Our ref 1765/SKR/L001

RE: Refurbishment of Roof, 45-47 Dale Street, Manchester

As requested, we have reviewed the boohoo proposals for the makeover of 45-47 Dale Street, Manchester, as shown on the Architecture:M drawings and in particular the works associated with the roof. We are pleased to comment on structural implications as follows.

Figure 3 – Example of a scarf joint

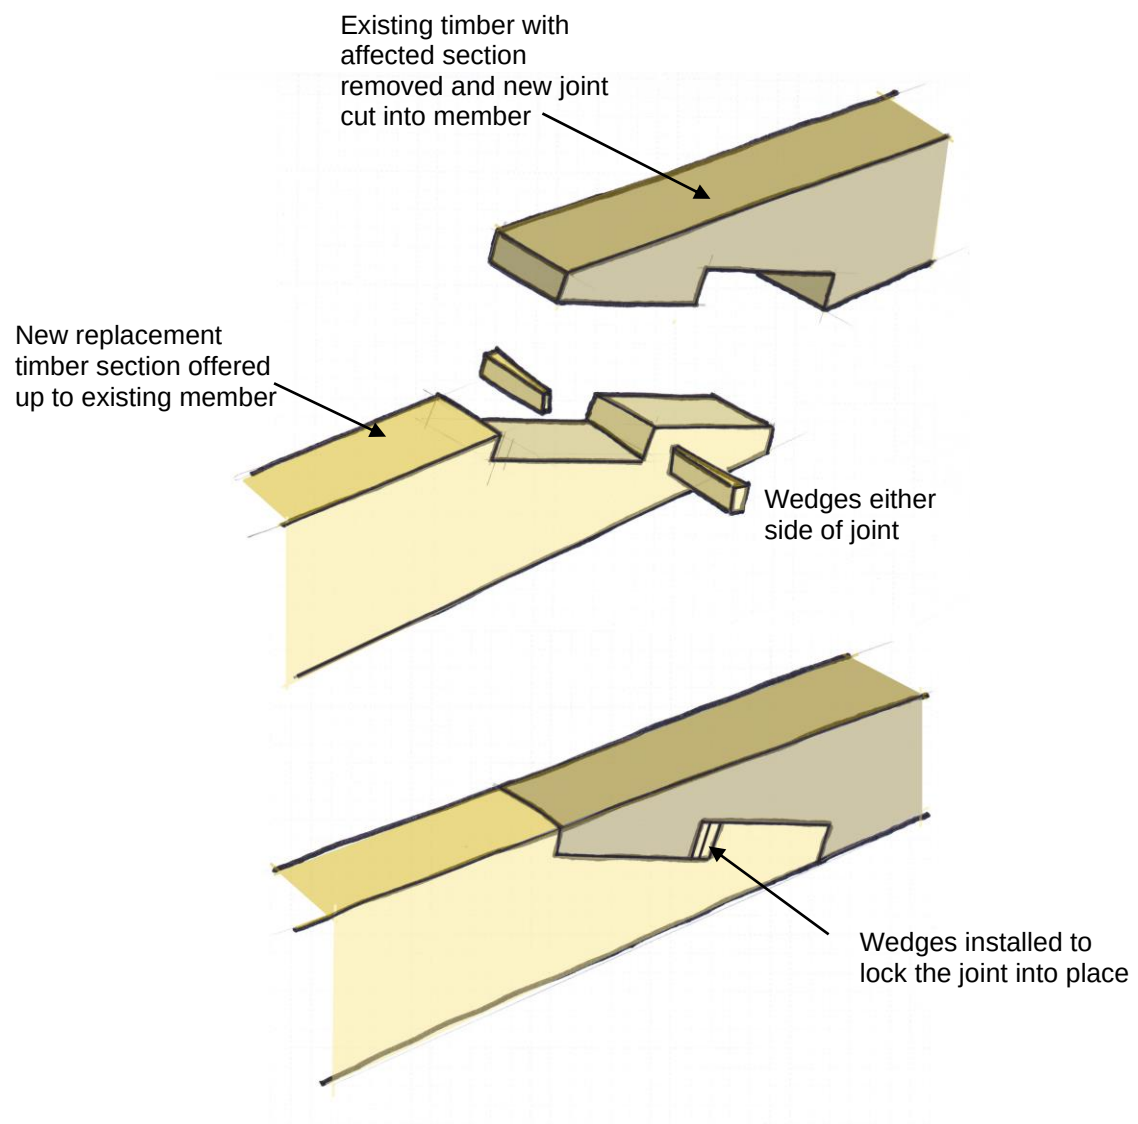
Where replacement of timber sections is required, it is proposed that the affected timber is cut out and replaced with the same species and grade of timber where possible, utilising scarf joints where appropriate to the situation. An example of a splayed scarf joint with a wedge system is indicated in Figure 3 and would be utilised at the end of members suffering from water damage and or rot.
